## Break Away with New U-Joint Kit

## GET A HANDLE ON REGULATING VALVE!

Get tailgate regulating valve  
with NSN 4820-01-132-0583

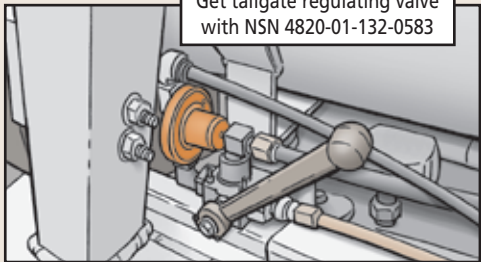
I recently ordered a new tailgate release valve, NSN 5340-01-443-3286, for my M1157A1P2 10-ton dump truck. It's shown as Item 5 in Fig 1487 of TM 9-2320-333-13&P (Jun 15).

When I received the release valve, there was no regulating valve mounted to it. Can you help me with an NSN for the regulating valve?

You bet! Get just the regulating valve for your M1157A1P2 with NSN 4820-01-132-0583. To prevent air leaks, use pipe sealant, NSN 8030-01-255-4144, on the threads before installing the regulating valve.

Make a note of the  
regulating valve's NSN until  
it's added to the TM.
